Ref No: ZSL00023

RX frequency coverage expansion

TX frequency coverage expansion

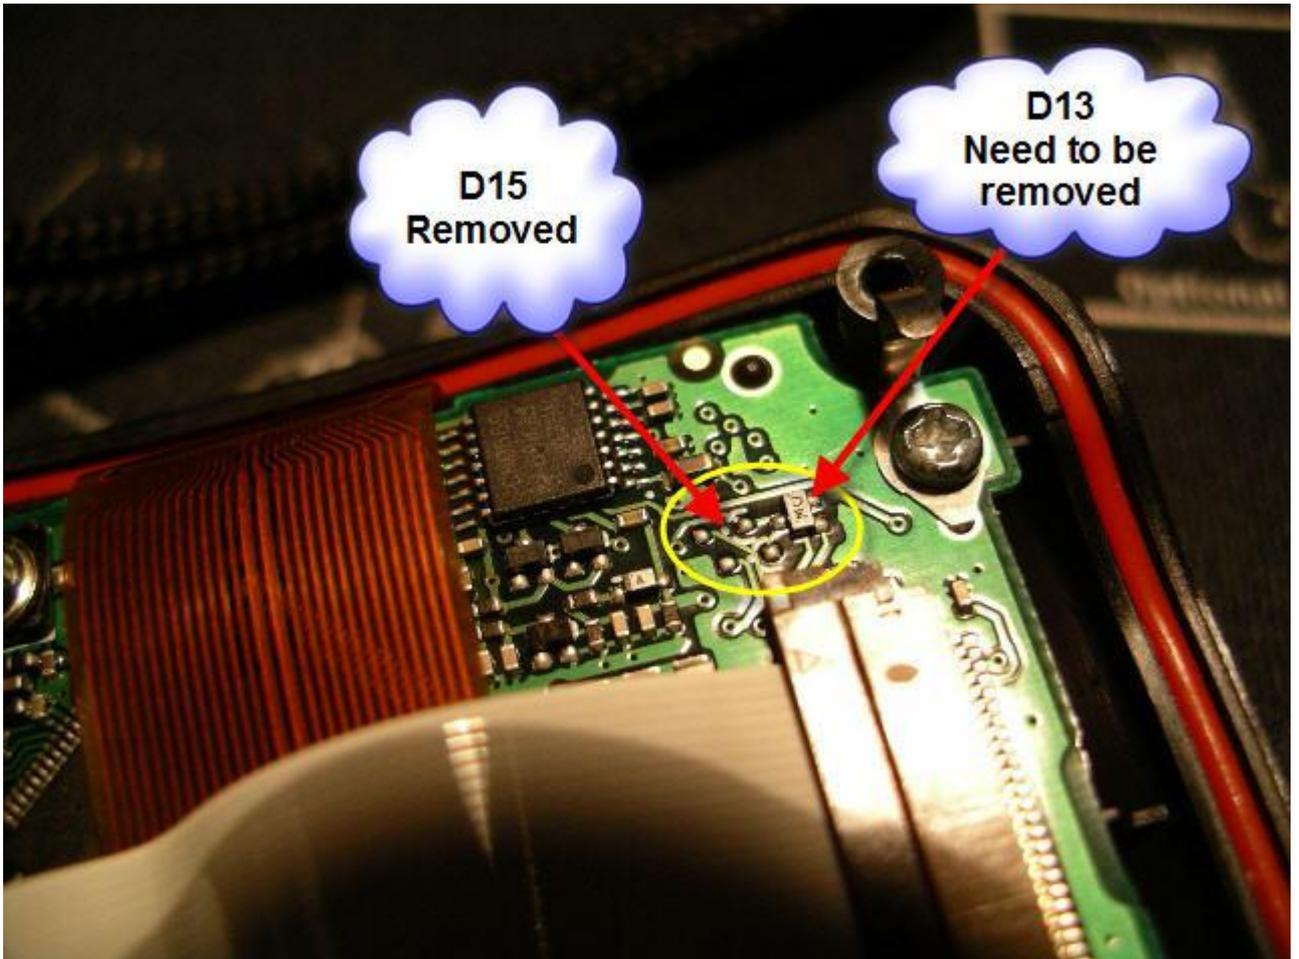
Remove D15 as shown below. While pushing [SQL] and [BAND], turn power on for Maximum frequency coverage.

After the RX frequency coverage expansion, remove D13 as shown below.
